Valentin Residence

ADDRESS ESA
RECOMMENDATIONS
TO CRITICAL AREAS
REPORT
May 15, 2018

File No. CAO17-003 – Valentin Critical Areas
Determination

4346 E Mercer Way, Mercer Island, WA 98040

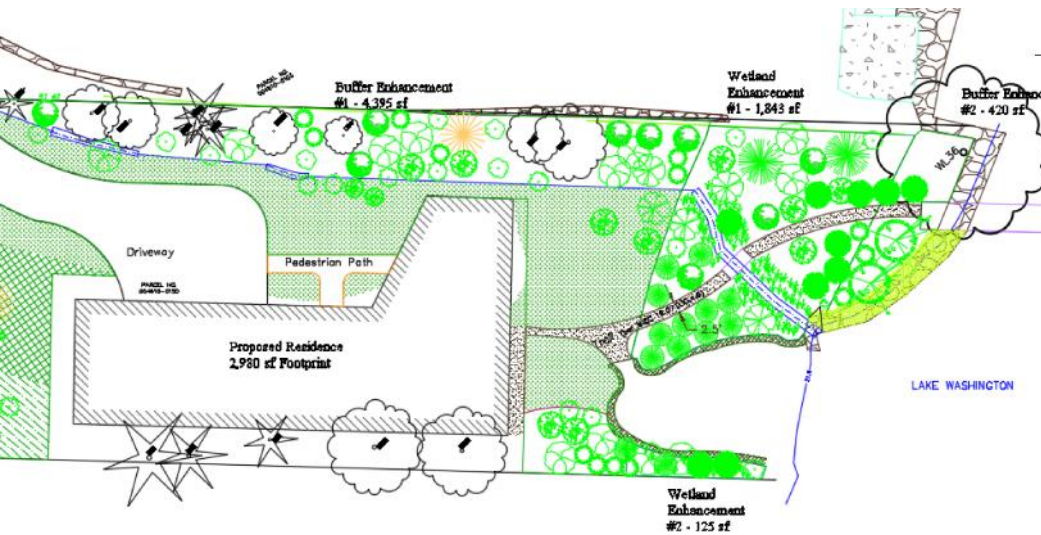
ESA Recommendation #1: The footprint of the proposed house extends to the edge of the reduced buffer. This does not allow adequate room for construction and maintenance of the proposed house without disturbing the buffer. Please add an adequate setback (not less than 5 feet in width) from the buffer for construction, and ongoing access and maintenance.

Although not required by code we have created a 3-5 ft path around the entire residence by revising and reducing the footprint. In most areas the path is outside the buffer. In limited areas the path is inside the buffer as an allowed alteration per MICC 19.07.030.A.6.

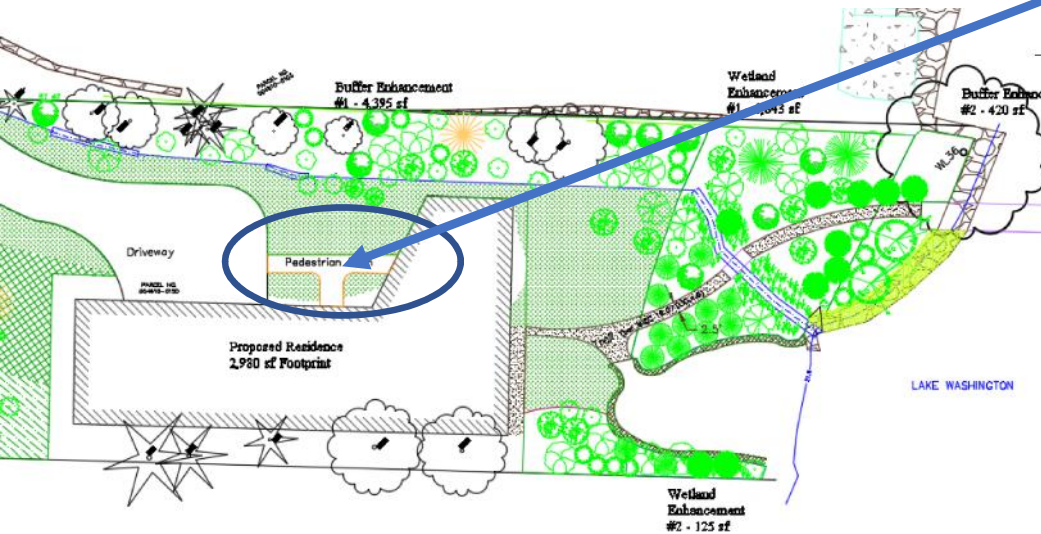
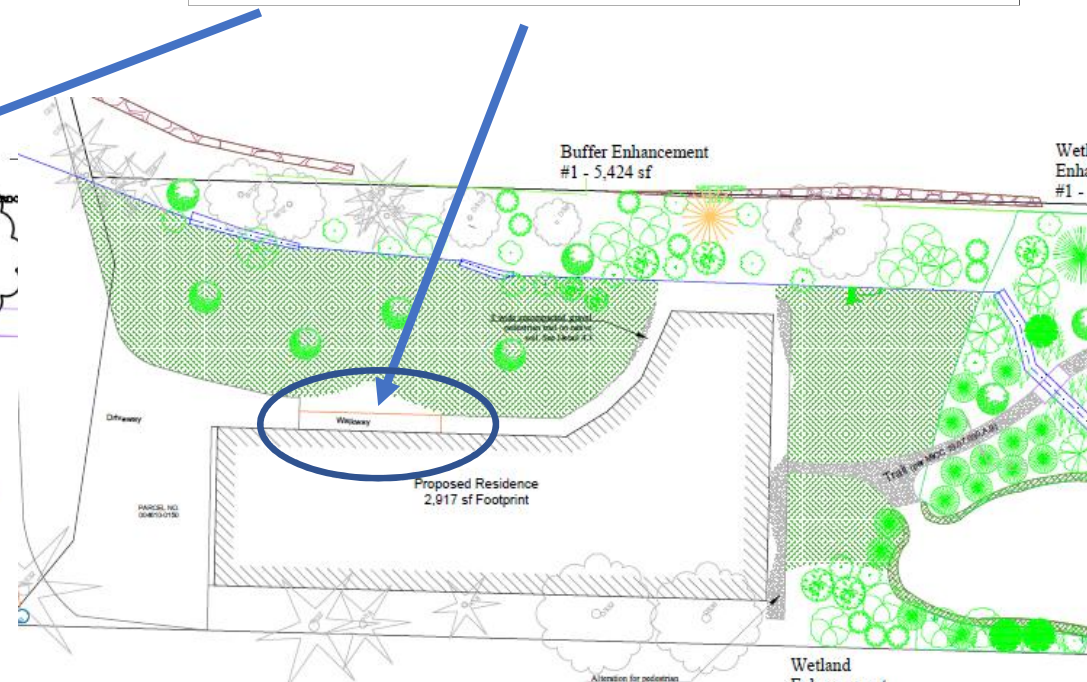
ESA Recommendation #2: On the plans, the walkway from the elongated parking area leading to the proposed house is labeled as a trail. This area is a walkway, not a trail. Please relabel as walkway. Walkways are not allowed in buffers, so the walkway must be removed from the reduced buffer area.

Walkway completely removed from within the reduced buffer.

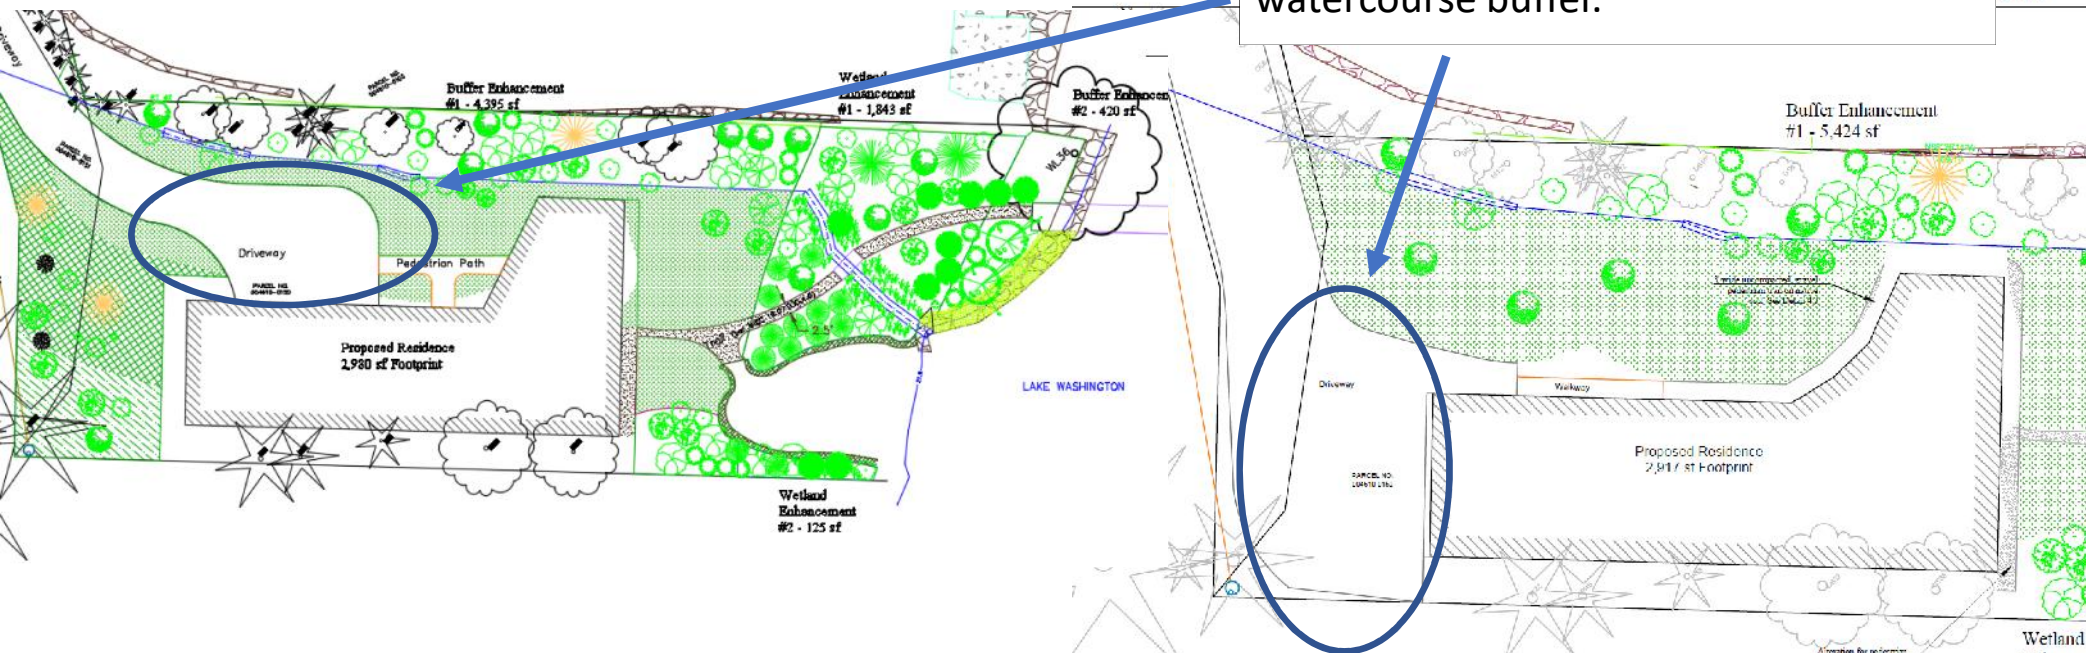
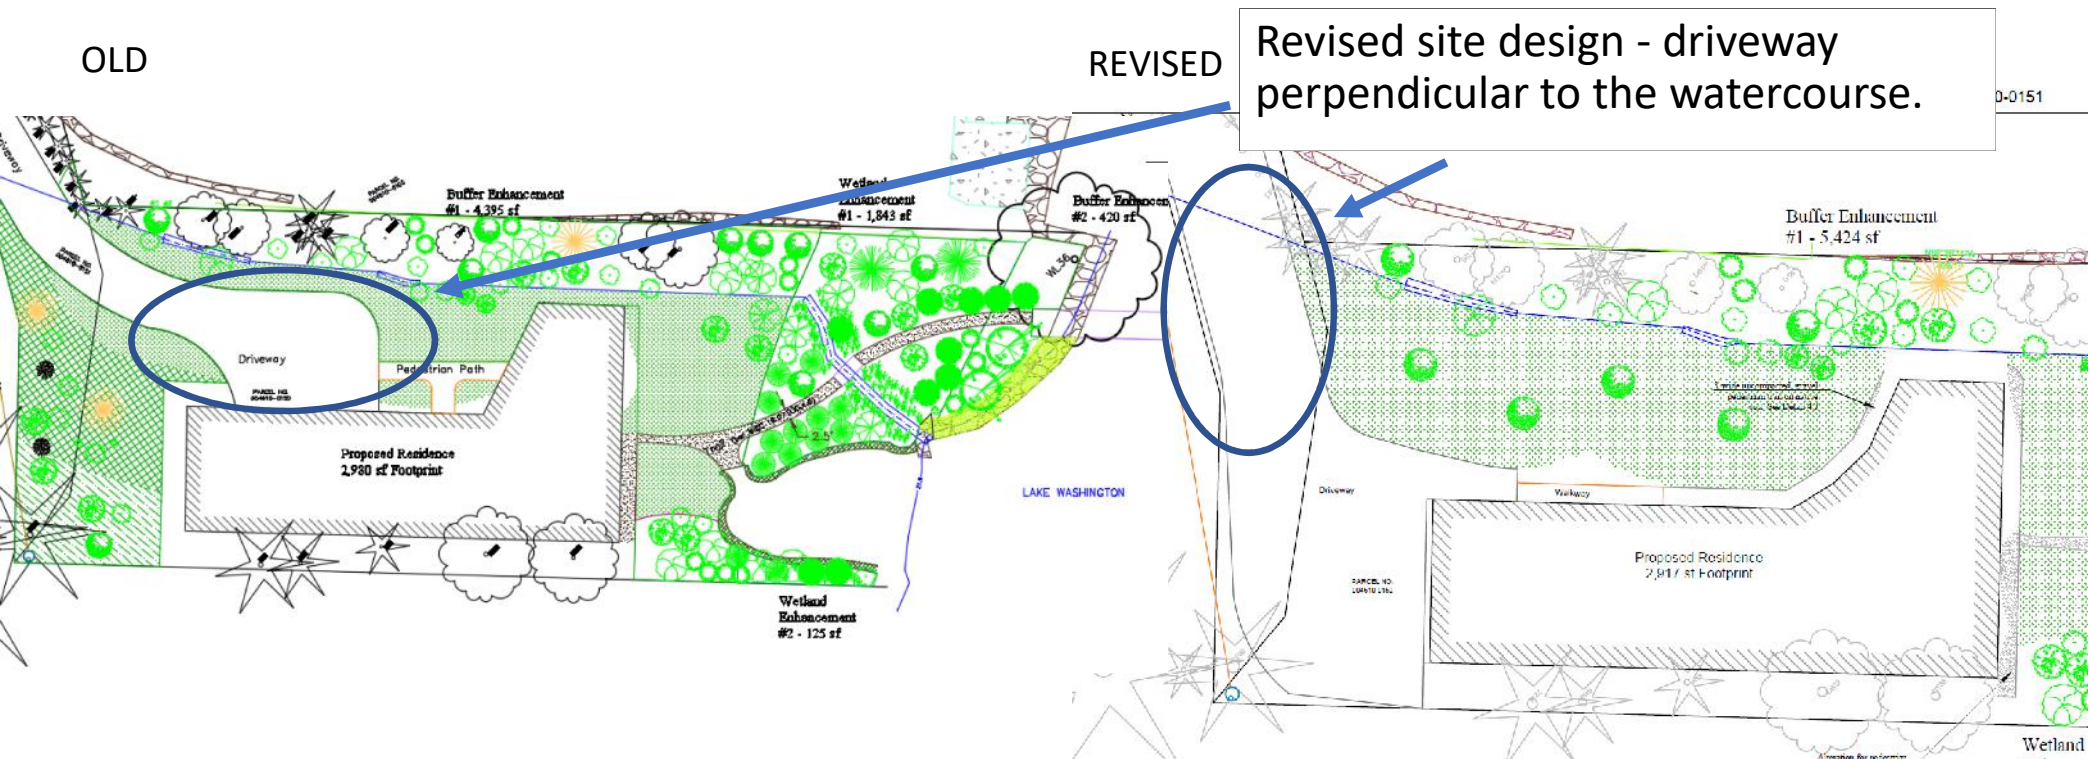
ESA Recommendation #3: To mitigate for reduced watercourse buffer widths, the project proposes to employ option (iii) under MICC 19.07.070(B)(2): removal of invasive species and ornamentals, replanting with native trees, shrubs, and herbaceous plants, and five-year monitoring. In addition, this mitigation type is proposed throughout Wetland A and most of the buffer areas. The enhancement activities are generally appropriate mitigation for the proposed reduced buffers. However, much of the Type 2 watercourse buffer is comprised of driveway pavement and parking area; a driveway crossing is allowable per MICC 19.07.030(A)(6); however, additional mitigation must be provided to offset the new intrusion of driveway in the buffer.

ESA Recommendation #4: A portion of the proposed driveway including the parking area at the terminus of the driveway is parallel with the water course within the buffer and is located within the reduced watercourse buffer. While driveways are allowed in buffers pursuant to MICC 19.07.030(A)(9), the layout is not consistent with best available science and does not avoid impacts to the reduced watercourse buffer. Best available science allows driveways to be placed in buffers perpendicular to critical areas to pass through or cross over the critical area. Please realign the driveway to be perpendicular to the watercourse to ensure no net loss of watercourse and buffer functions; a revised site design is appropriate.

Driveway and parking area completely removed from the reduced Type 2 watercourse buffer.

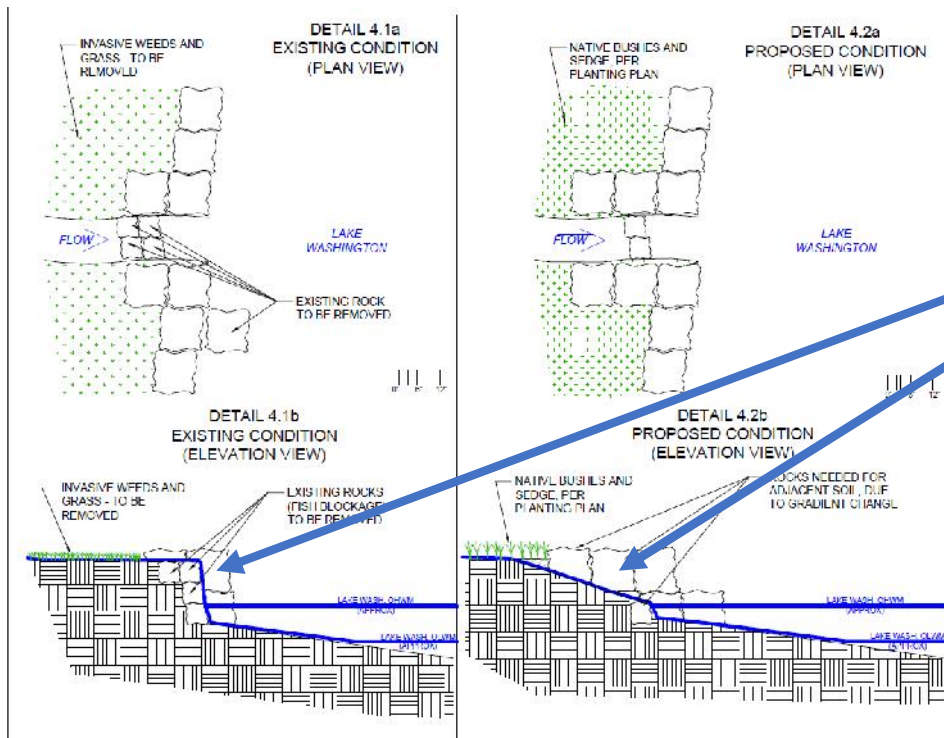
ESA Recommendation #5: The Critical Areas Study proposes mitigation via habitat enhancement within the watercourse with log placement. The stream is too narrow to benefit from log placement. Rather than log placement, please remove or soften the existing rock bulkhead adjacent to the watercourse outlet to the lake. As part of this work, remove all blockages between the lake and the outlet.

Soften existing rock outlet and remove blockage, see proposed design detail to the left.

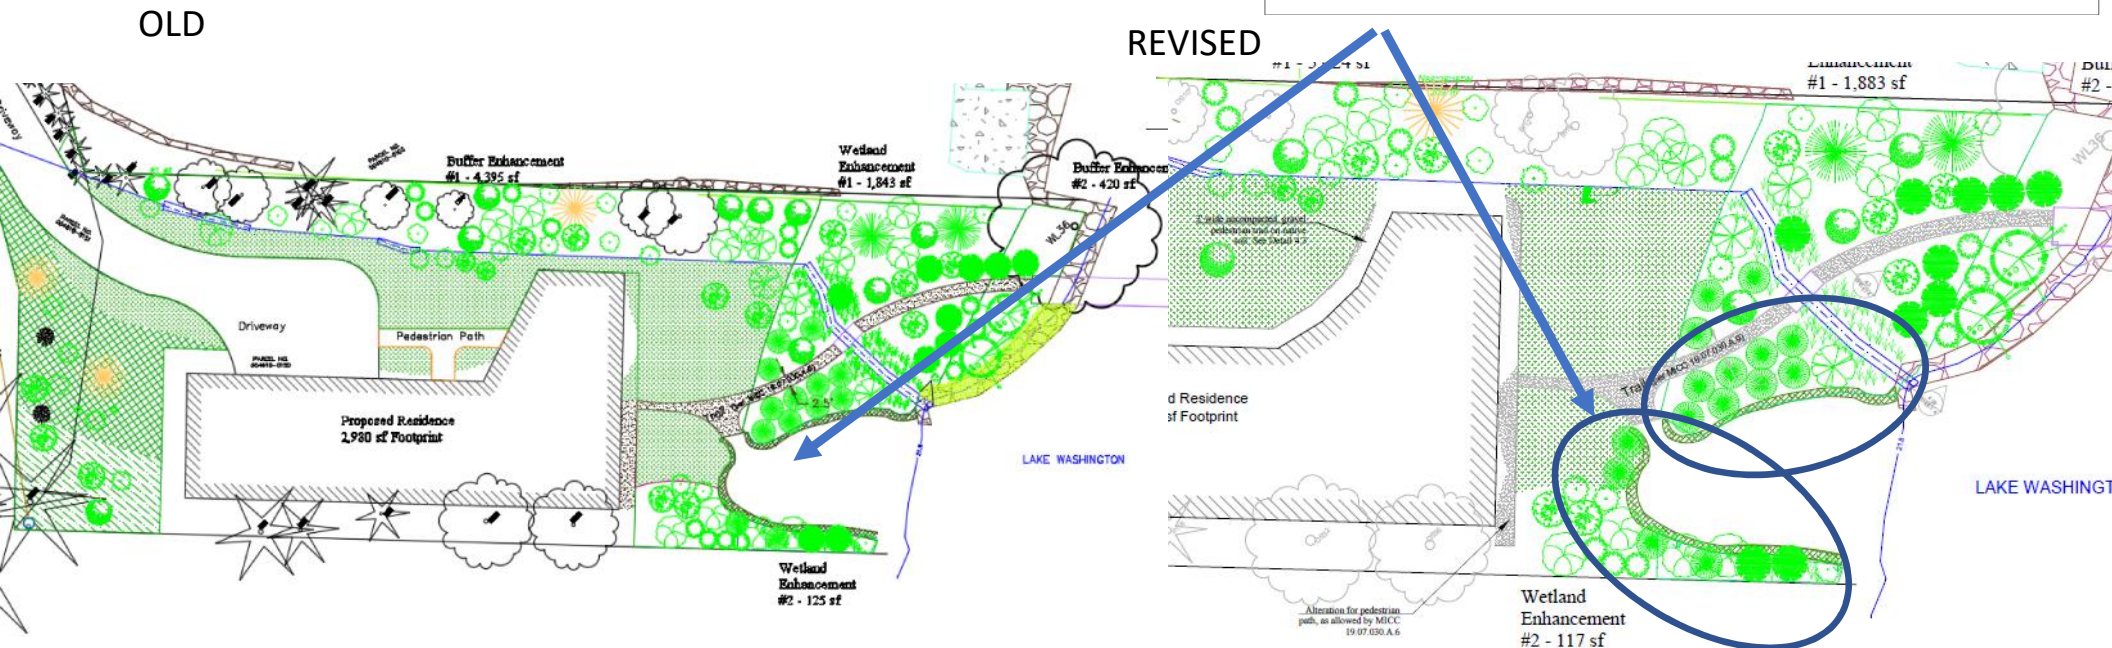
ESA Recommendation #6: Pursuant to MICC 19.07.110(E)(9)(d)(i), native vegetation should be planted to meet or exceed 75 percent cover in the area within 20 feet of the Lake Washington OHWM. However, a sandy cove exists within this 20-foot area. To meet the intent of the code, please enhance the proposed plantings adjacent to the cove by adding native shrubs that will provide habitat value not provided by the proposed groundcover plantings in this area.

Added plantings adjacent to cove which are all native shrubs. In addition, the cove itself provides enhanced habitat.

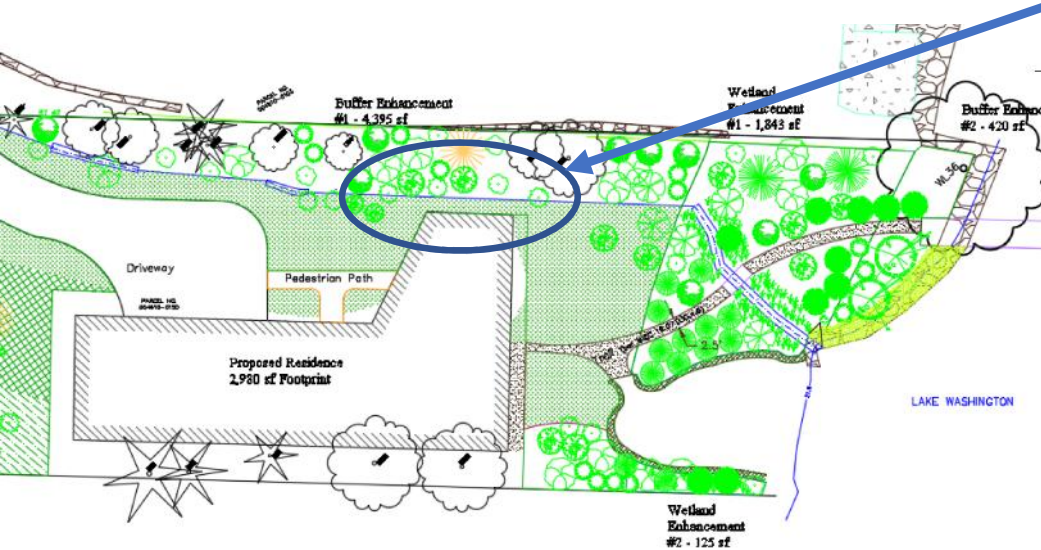
ESA Recommendation #8: The “buffer enhancement and mitigation” area shown on the Impacts and Buffer Mitigation sheet includes non-buffer area (southwest corner of parcel). There are no issues with enhancing this area; however, it should not be included in the total buffer enhancement area calculation.

Removed non-buffer area calculations.

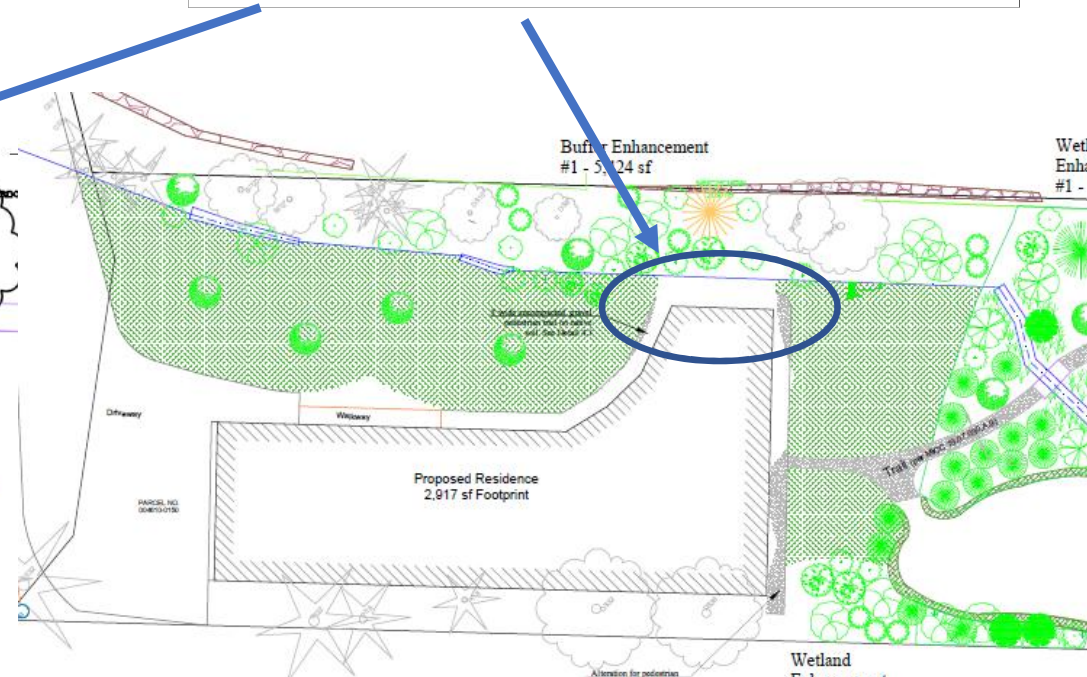
ESA Recommendation #9: The three-foot proposed reduced buffer from the piped watercourse does not allow for future daylighting of the stream and therefore results in net loss of watercourse and buffer functions. Please proposed a larger buffer that will result in no net loss; please increase the buffer width and provide documentation indicating that the revised width will allow for future daylighting of the watercourse.

As discussed with the City, increased setback to 5 feet to allow for future daylighting (not proposed or part of this project).

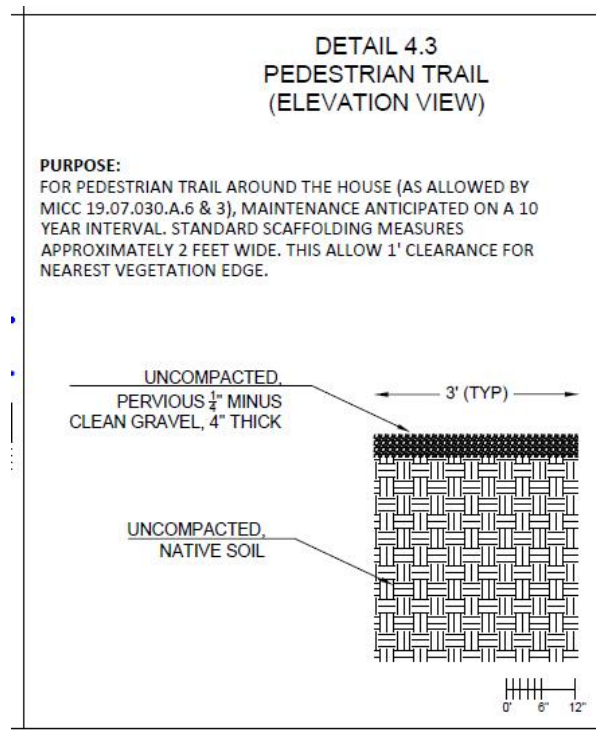
ESA Recommendation #10: (Previous Review Comment) Detailed plans should be provided for the proposed trail and bridge to document materials, construction methods, and mitigation to ensure consistency with MICC Chapter 19.07 allowances, and to adequately compensate for wetland, stream, and buffer impacts. The updated Critical Areas Study and Mitigation Plan sheets do not discuss the proposed trail and bridge that provide access to the dock or detail the construction methods or proposed materials. Per MICC 19.07.030(A)(9), trails should be made of pervious materials, unless the code official determines impervious materials are necessary to ensure user safety. Please provide this information.

Details have been added to the mitigation plan. This is our fault, it was an oversight in the previous submission.
